Response to Objection to Outline planning permission for Extension of MIRA Technology Park

Technical Note

Client Name: ERI MTP Limited

Document Reference: EED13833-118-TN-5-1-2

Rev	Date	Description	By
Amendments			
Project			
MIRA Technology Park South Site			
Title			
MIRA Southern Manufacturing Sector Surface Water Attenuation Summary Southern Catchments			
Client			
ERI MTP Limited

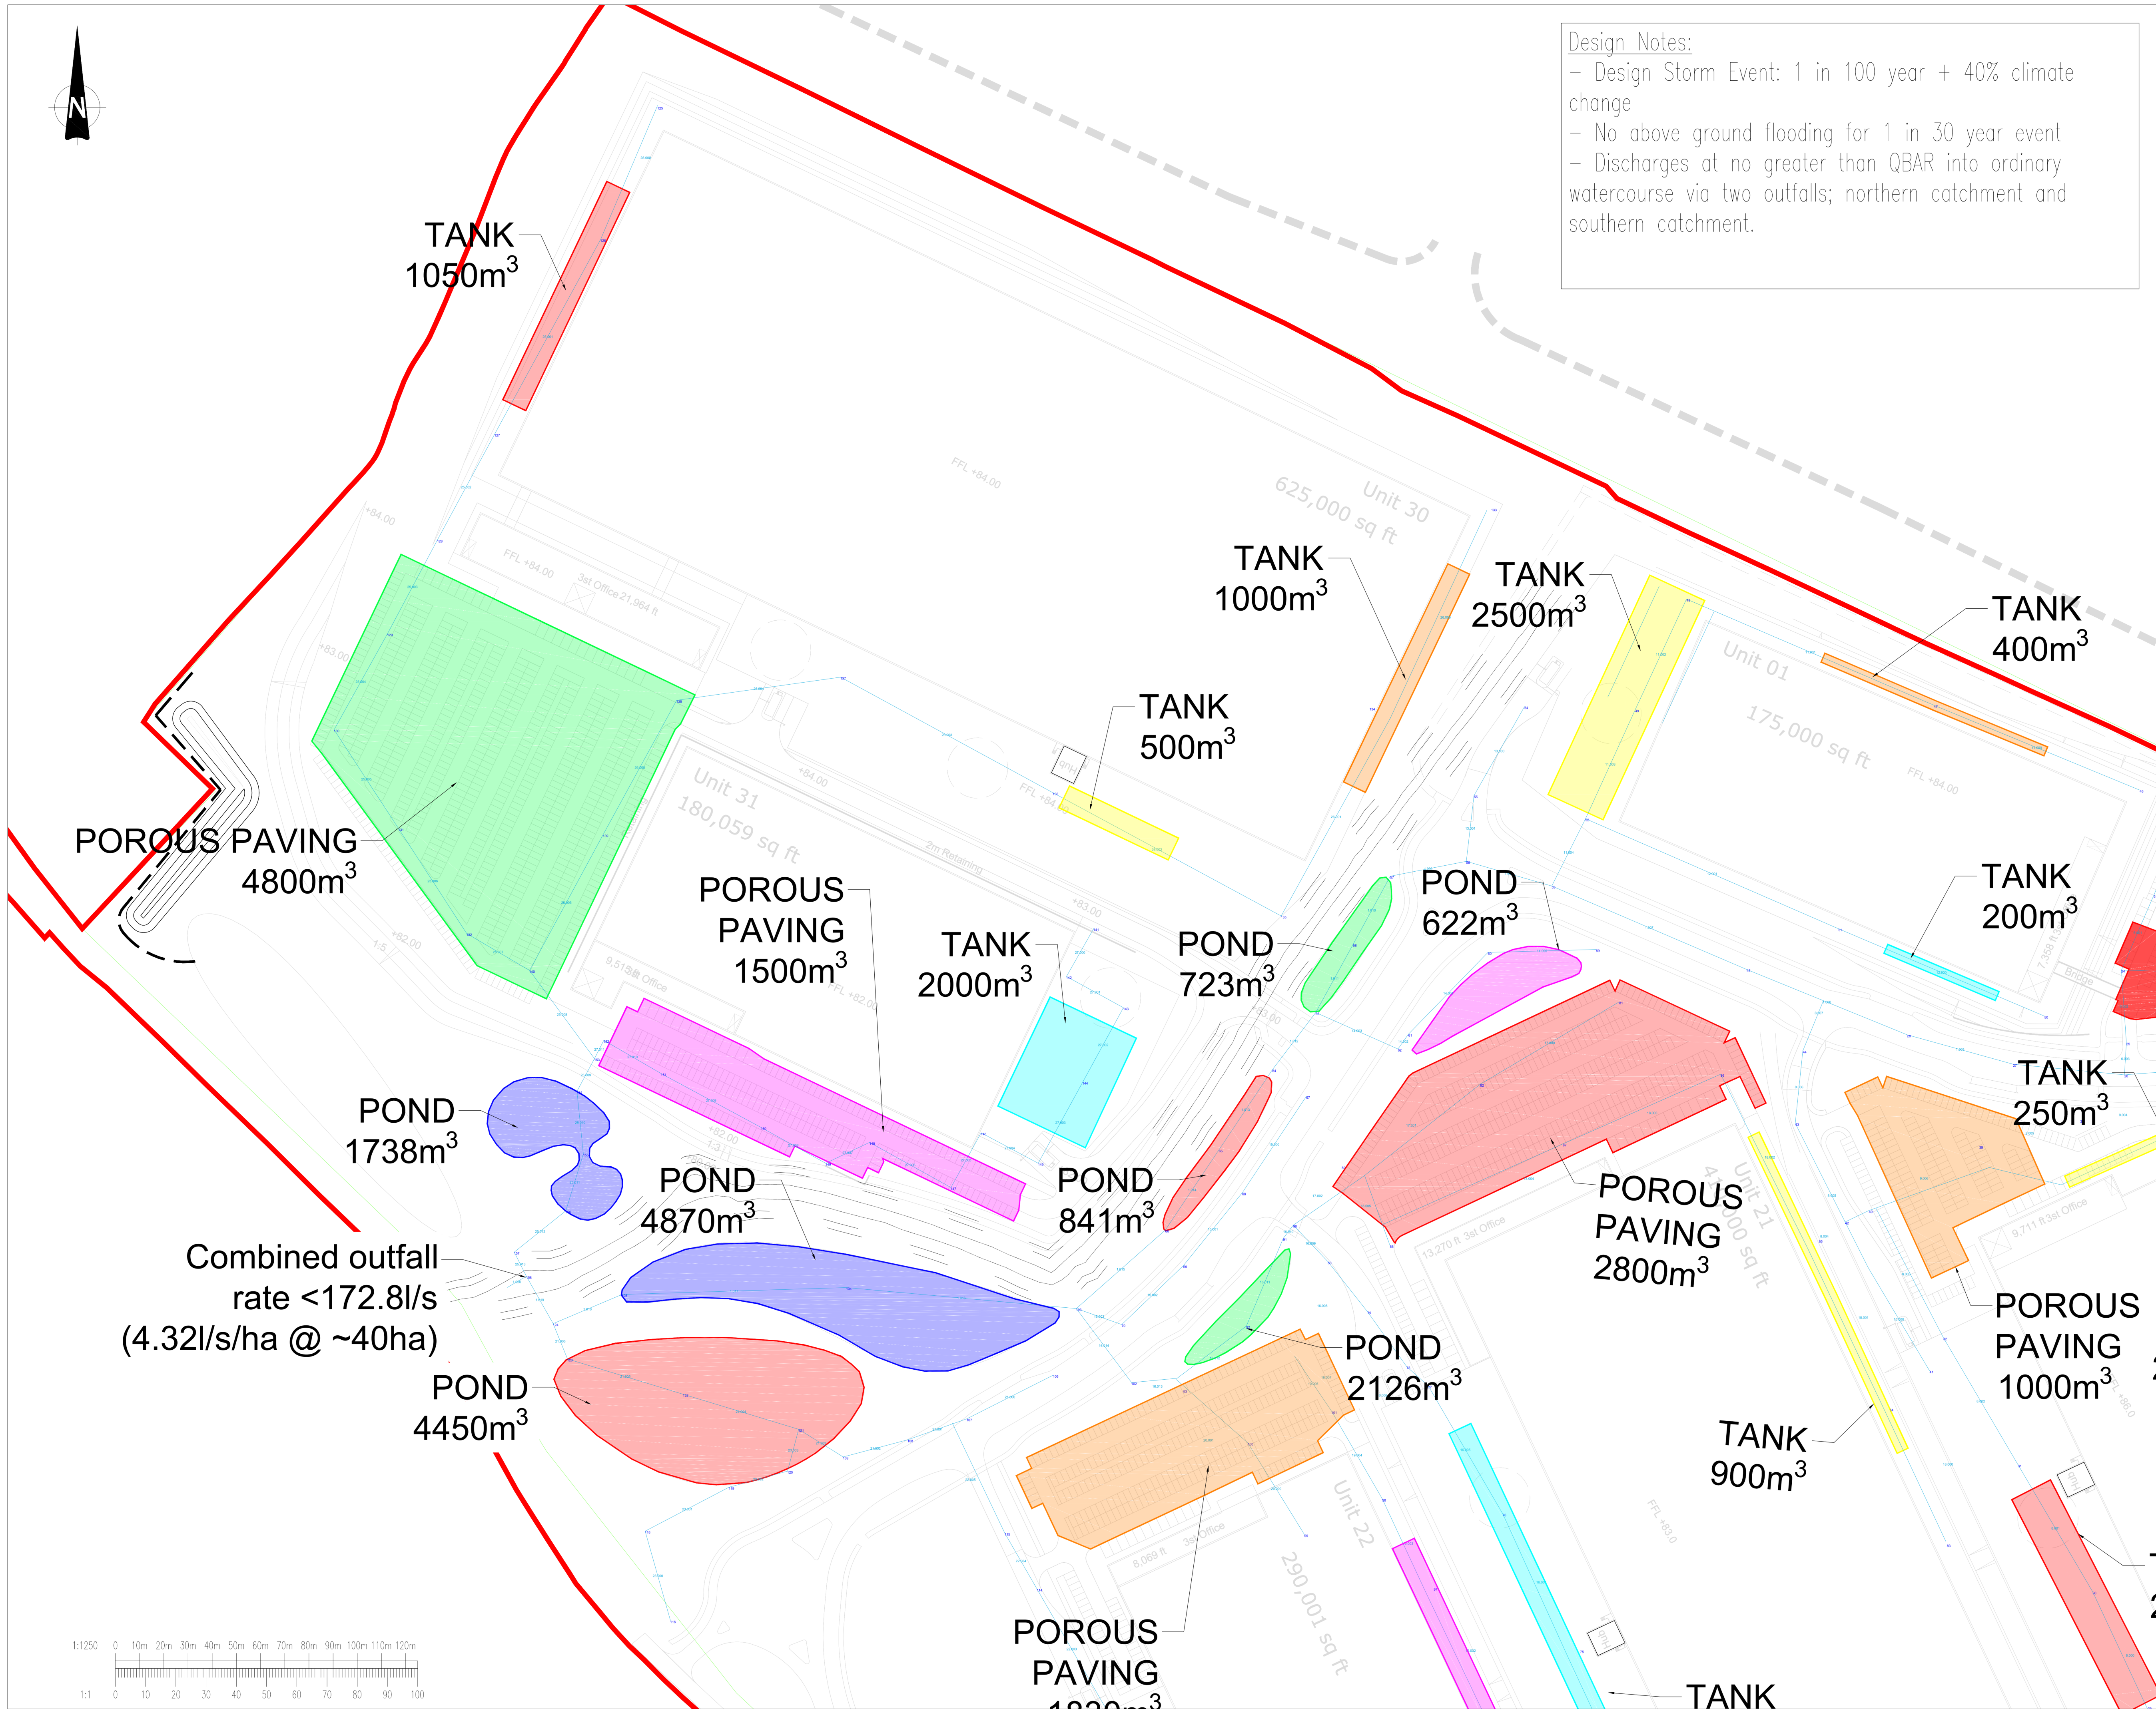
1. Given the proposals to revise the drainage strategy so that an adequate buffer alongside the on site watercourse can be provided and limit the site discharge rate to 4.32l/s/ha, the LLFA

requires evidence to illustrate that it is possible to provide a viable drainage scheme that meets these criteria. Supporting evidence should include:

- a. A revised Indicative Surface Water Drainage Strategy to illustrate the nature and layout of the proposed drainage features.
- b. Calculations to demonstrate that there is adequate attenuation to limit the site's discharge to the appropriate greenfield run off rate.

- 1.1. This note provides the supporting evidence to confirm that the attenuation volume designed in the original FRA (EED13833-118-R-2-4-3-FRA) submitted as part of the outline planning application remains same even for the reduced discharge rate to 4.32l/s/ha. This has been achieved by using

hydrobrake to optimise the upstream hydraulics instead of the orifice as flow control device, as such, 16No. orifice flow control devices have been replaced with hydrobrakes.

- 1.2. The total Site area within the red line boundary is 59.5ha. As the watercourse bisects the Site, it will be necessary to provide two outfalls which serve the areas to the north and south of the watercourse, henceforth referred to as the 'northern catchment' and 'southern catchment' respectively. The outline drainage strategy layout in Appendix B shows the indicative location of these outfalls.

- Design Storm Event: 1 in 100 year + 40% climate change
- No above ground flooding for 1 in 30 year event
- Discharges at no greater than QBAR into ordinary watercourse via two outfalls; northern catchment and southern catchment.
